Product Change Notification

Date Issued :	June 05, 2026	PCN Number :	518256
Reason for Change :	Equipment Transfer, Production Transfer or Rearrangement		
PCN Subcategory:	EMR - Equipment/Tool Transfer		
Description of Change :	This notification is to inform that equipment previously used in the manufacture of impacted part(s) will be transferred to a different site/location/premises. There will be no changes to the product design, specifications, or manufacturing process as a result of this transfer.		
Assessment of Change :	First Article Inspection		
Planned Implementation Date :	December 18, 2026		
Customer Sample Availability Date:	July 31, 2026		
Last date to request Samples by Customer : August 28, 2026			
Please note if Samples are not requested as per Customer Samples Request date, it may take additional 4-6 weeks to arrange Samples.			
Traceability Code Markings / Date :	Date code

Product Illustration (Impact OD/RAM/MEZZ Family)

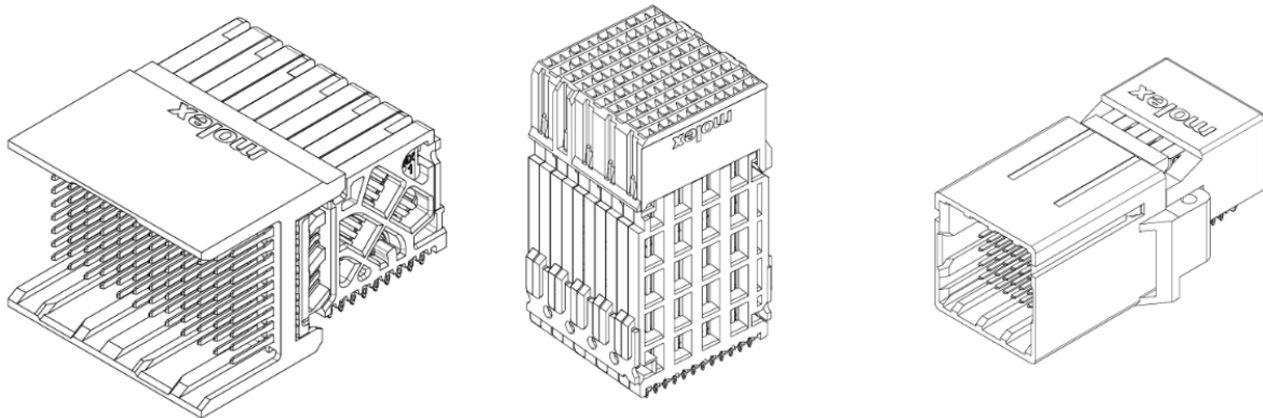
- As a valued customer, we wanted to notify that:
 - Molex Singapore is developing additional production area for assembly process to support connector market demand
 - There will be no change to the Country of Origin (COO), as the additional production area will remain in Singapore
- Product Impact
 - no impact to fit, form or function
- Part Number Impact
 - Refer to attached impacted part no list
- Qualification part selected below is representing the high runner product, qualification report and samples available upon request for other impacted part number
- PCN will be implemented once all required qualification/validation has been completed and all necessary approvals have been obtained.
